UNITED STATES PATENT AND TRADEMARK OFFICE

APPLICATION NO.	FILING DATE	FIRST NAMED INVENTOR	ATTORNEY DOCKET NO.	CONFIRMATION NO.
10/688,750	10/17/2003	Paul J. Mollinger	CPS1540-241	1991

Office Action Summary

FIG-4

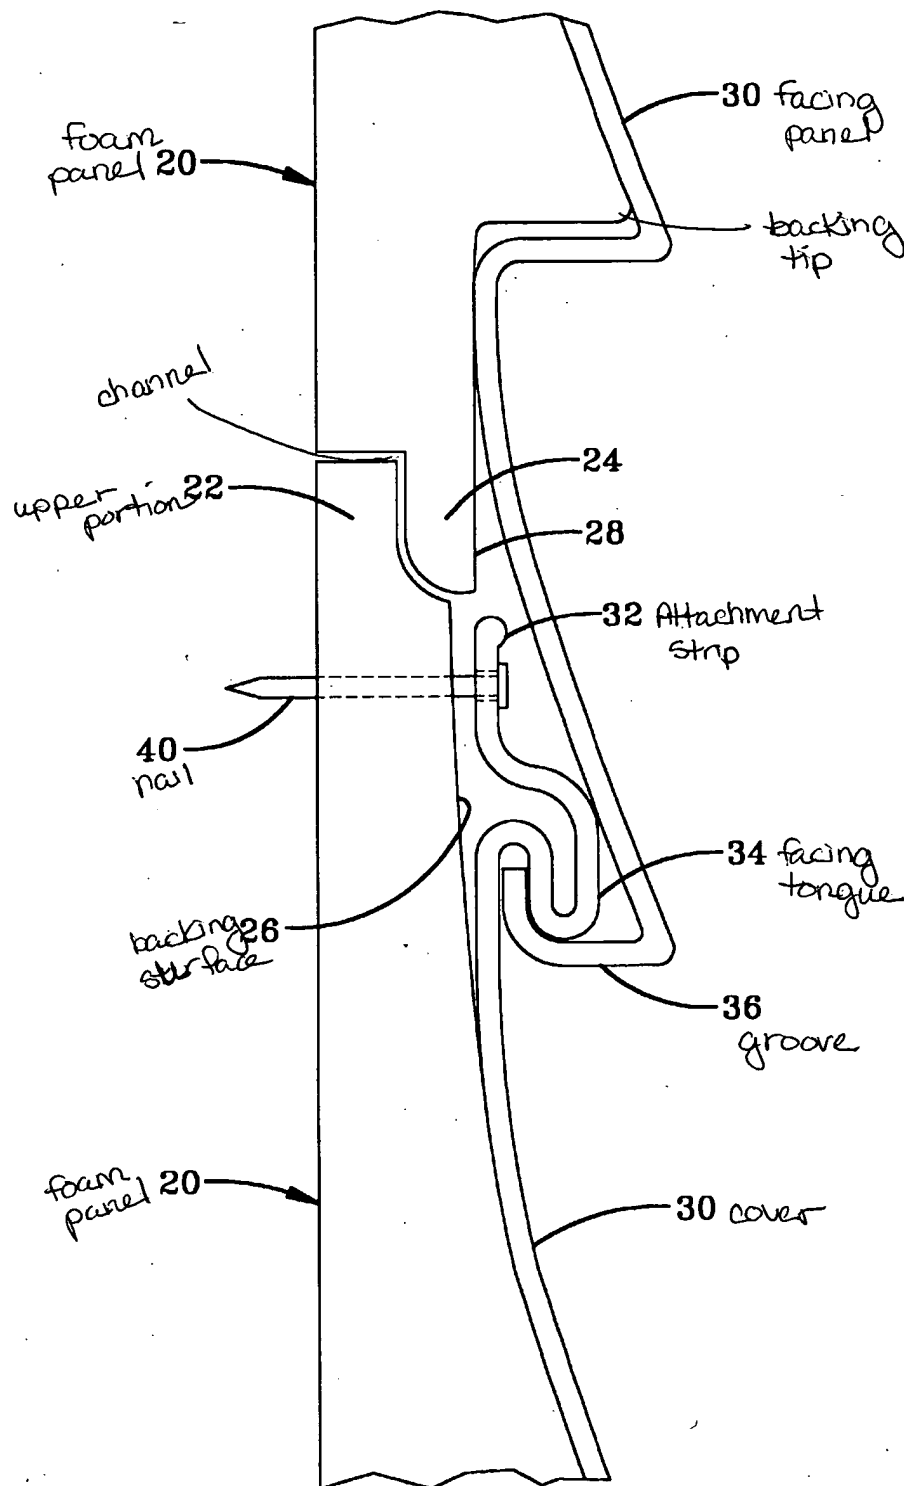
Regarding claims 1-9 and 25, Manning et al. discloses, in figure 4, a paneling unit comprising a cover portion (30) having an attachment strip (32), and a backing portion having a bottom portion in a rear side defining a channel (20). Manning et al. discloses a foam backing panel with a solid surface but does not disclose that the panel has groove members. Bynoe discloses roofing panels that consist of hydraulically connected drainage and connector grooves (see fig. 1, and Col. 4, lines 30-63). Where each of the drainage and connector grooves are for the drainage of liquid and extend from one edge of the backing portion to another and where the connector and drainage grooves on the first portion of the backing system form at least a segment of a continuous connector groove with a surface of an adjacent backing portion when installed adjacent to a structure covered by a panel unit. It would have been obvious to one skilled in the art to

Regarding claims 21-23, Manning et al., as modified, discloses a panel unit as described in claim 1 where the cover portions substantially abuts and wraps around a tip of the backing portion adjacent to the attachment strip (see attached drawing). Where the attachment strip is a nailing strip and is substantially in the same plane as a rear side of the backing portion (32 on fig. 4).
